# Product Change Notification (PCN)

- PCN#507601 - 10B & 24B HC Top & Side Entry Hoods Round shaped

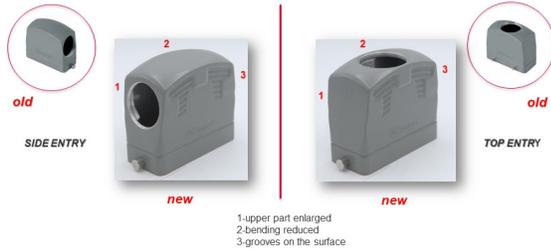
- As part of our continuous improvement process, we/Molex HDC have upgraded our 10B & 24B High Construction hoods, Top & Side entry – same as already done with the 16B size.
- The upper part of the hood has been enlarged (see picture point 1), the bending at the top has been slightly reduced (see picture point 2).
- This change will ensure a better performance even when connected to cable glands of bigger sizes, such as PG29 and M40.
- Even the aesthetic of the surface has been renewed with a new design for the grooves (see picture point 3).
- This change involves both the form and the function of the products.
- See attached impacted parts list.
- Qualification Reports and samples available upon request after the date shown above.
